ECE/TRANS/WP.29/GRE/2009/33
17 July 2009

REGULATION No. 48
(Installation of lighting and light-signalling devices)

Automatic activation of the hazard warning signal

Proposal for Supplement 5 to the 04 series of amendments to Regulation No. 48

Para. 6.25.7.5:

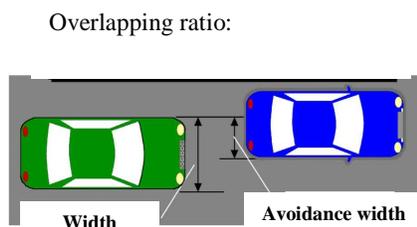
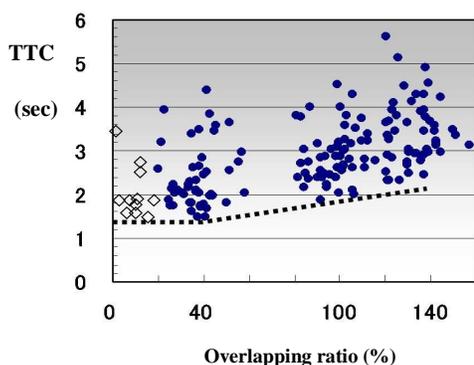
The intention of these requirements is to ensure that RECAS only activates in emergency situations. According to the result of the 3rd Advanced Safety Vehicle Project^{1/} conducted in Japan, under ordinary driving conditions, manoeuvres occur at least 1.4 seconds before a potential rear-end collision. See charts below:

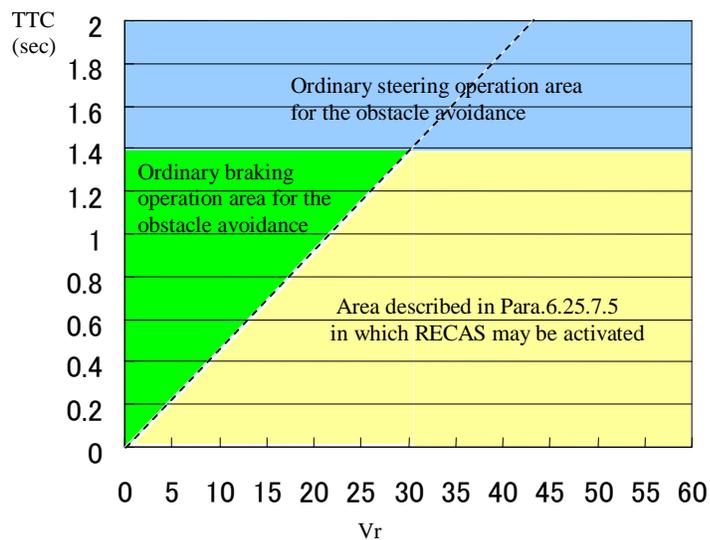
According to the above results, a system which would only be activated when the Time To Collision (TTC) is below or equal to 1.4 seconds, would not have any negative influence on the regular traffic flow. However, it would remain effective in case of an emergency situation, by allowing enough time for the driver to perform a collision avoidance manoeuvre.

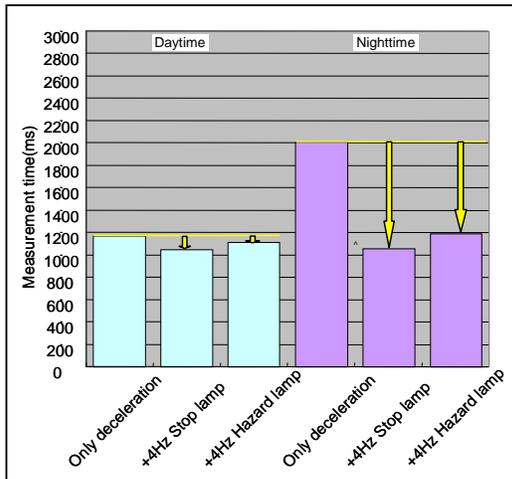
To simulate a driver who is looking ahead but is not concentrated, the driver of the following vehicle reads out the random number which is showed in centre of the table.

Test Result]

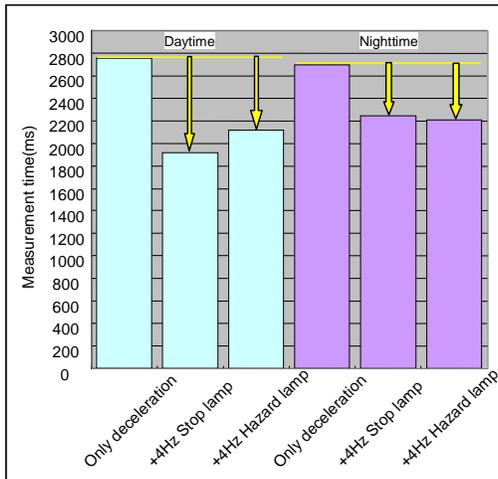
According to the test result, there is no significant difference between red and amber colours.
